Flight Procedures Cover Page	Task Action: FLIGHT CHECK	Task Type: IAP	Estimated Chart Date: 07/09/2026	APWS Task ID: 5CE1EB63E44B4F38BAC384AD191D25BF	APWS Project ID: BBB3440016BF446588252E58DD933ABD
Procedure: LOC BC RWY 12 AMDT 12		Enroute: NO	Specialist: Young, Silvia		Agreement Number:
Airport ID: KMCE			Airport City: MERCED		State: CA
Facility ID: MCE	Facility Type: ILS	Flight Inspection Remark Type: New FC Slot			
Procedure Comments: ACTIVE DATA USED FOR KMCE AIRPORT, RWYS, I-MCE, MOD VOR/DME AND HYP VOR/DME. CANCEL NOTAM FDC 5/6810. CONTACT CASIMIR TABAKA 405.202.7857 06/30/26: THIS IS A CORRECTED COPY OF THE FORM APPROVED ON 22/06/26. F FILE: 1. TERMINAL ROUTES: CHANGED FIX NAME FROM CAZAR TO JENED. 2. MAP: CHANGED FIX NAME FROM CAZAR TO JENED. 3. PROFILE LINE 3: CHANGED FIX NAME FROM CAZAR TO JENED. 4. PROFILE LINE 4: CHANGED FIX NAME FROM CAZAR TO JENED. 5. ADDITIONAL FLIGHT DATA: CHANGED FROM "CAZAR TO RW12: 3.00/53" TO "JENED TO RW12: 3.00/53". 8260-2: CAZAR. 06/30/2026: THIS IS A CORRECTED COPY OF THE FORM APPROVED ON 06/22/2026 FIX TYPE OF ACTION: CHANGED FROM MODIFY TO CANCEL. JENED: ADDED REV 2.

FIPC BASIC FORM						
PROCEDURE: LOC BC RWY 12 AMDT 12			AIRPORT NAME:

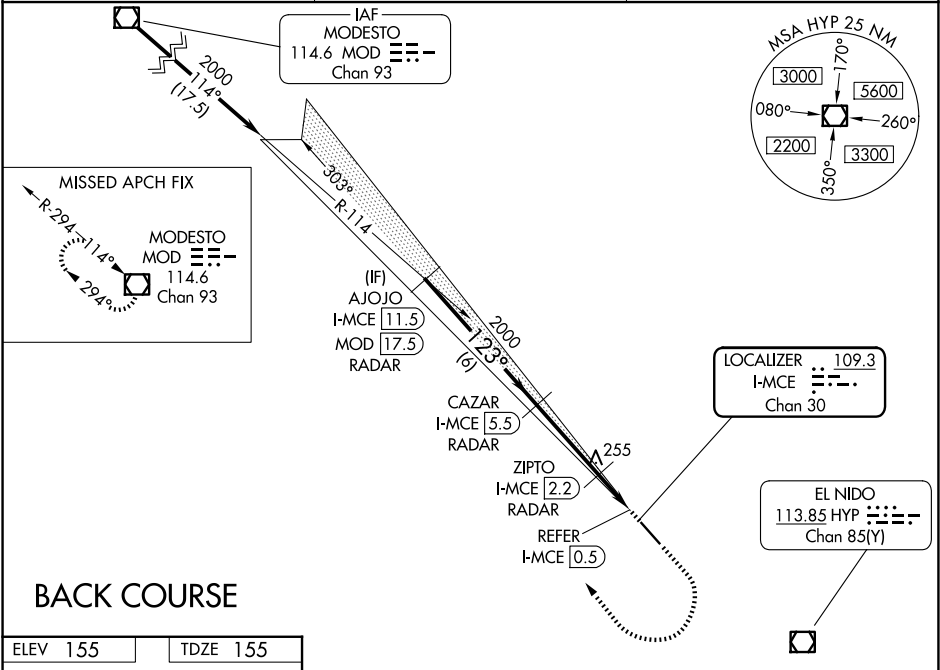
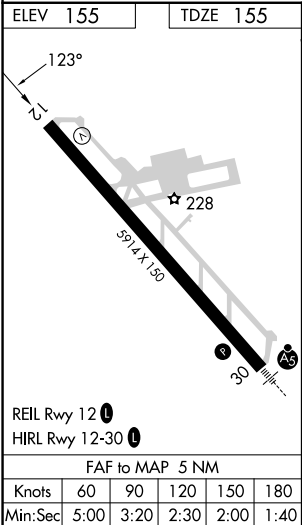
FIPC BASIC FORM							
PROCEDURE: LOC BC RWY 12 AMDT 12			AIRPORT NAME: MERCED YOSEMITE RGNL		AIRPORT ID: KMCE	SPECIAL CONTROL NO: SP-06-225-26	
FAC ID: MCE		CITY: MERCED			ST: CA	ORIG CHART DATE: 09/03/2026	
DFL TYPE: PROC/A	THIRD PARTY: ☐ YES	EST. TIME ON SITE: 0.4	REIMB. NUMBER:		PTS TASK ID: 5CE1EB63E44B4F38BAC384AD191D25BF		
PREFLIGHT NOTES							
REVIEWER:					DATE:		
COMMENTS:					CHECK ONE:		
					☐ FLT CK REQ ☐ NFCR ☐ REJECT		
							YES
					CPV COMPLETE?		X
PROCEDURE RESULTS							
INSPECTION DATE: 06/18/2026	CREW #: VN569	N #: N72	INSTRUMENT PROCEDURE STATUS: ☒ SAT ☐ SAT W/CHANGES ☐ UNSAT			ARINC CODING: ☐ SAT ☐ SAT/GOLD ☐ UNSAT	
FLIGHT INSPECTOR SIGNATURE: wendi s gima @ 06/18/2026 14:09			PRINTED NAME: GIMA, WENDI SUEMI				NOTAM INITIATED? ☐ YES ☒ NO
FLIGHT INSPECTOR REMARKS: MERCED YOSEMITE RGNL, MERCED, CALIFORNIA, LOC BC RWY 12 AMDT 12, SAT. This amendment did not require flight inspection. Changes: minor wording changes in description, no change in procedure. Eliminated unnecessary stepdown at ZIPTO mins column since DME or RADAR are required for procedure.
